Responses to Sierra Club Data Requests – Nos. 98 through 131

Amended Application for Certification for HYDROGEN ENERGY CALIFORNIA (08-AFC-8A) Kern County, California

**RESPONSES TO DATA REQUESTS 98 THROUGH 131
FROM SIERRA CLUB**

Figure 127-1
HECA Climate Data

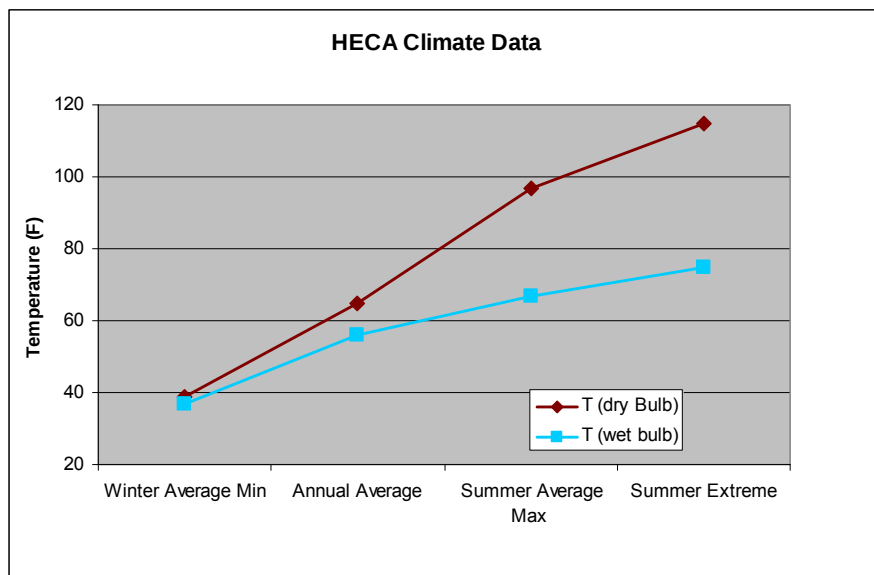
- 127. Please fill-in the table below and provide the total capital costs, energy costs, and O&M costs associated with all elements of the water supply system providing water to the three onsite cooling towers, including: the five water wells in the BVWSD service territory, the 15-mile pipeline from these wells to the Project, the raw water treatment plant, the three cooling towers, and the ZLD system, and any other facilities or equipment that may be required.**

Air cooling was not selected because it results in a substantial increase in parasitic electrical demand and a dramatic decrease in power output. These effects result in a markedly negative impact on the cost and availability of electricity. Just for the combined cycle portion of the facility alone, comparison to CEC studies would indicate that the efficiency loss results in reduced power output of over 15 MW.

From a thermodynamic point of view, air cooling requires the heat rejection temperature to be above the ambient dry bulb temperature. Using mechanical draft cooling towers allows the heat rejection temperature to be somewhat above the ambient wet bulb temperature. As indicated in Figure 127-1, an additional 30 to 40 degrees of temperature driving force is available using water cooling because the difference between the dry bulb temperature and the wet bulb temperature is much higher on hot summer days than the annual average day. Since the need for power and the price for power is much higher on hot summer days, the loss in power output comes precisely when it is most valuable and needed in the California Independent System Operator (CAISO) grid. The process areas associated with an IGCC have many pieces of equipment as compared to a power block which only has a final condenser serving the steam turbine generator. Figure 127-1 illustrates how the heat rejection temperature penalty for air cooling increases on hot days.
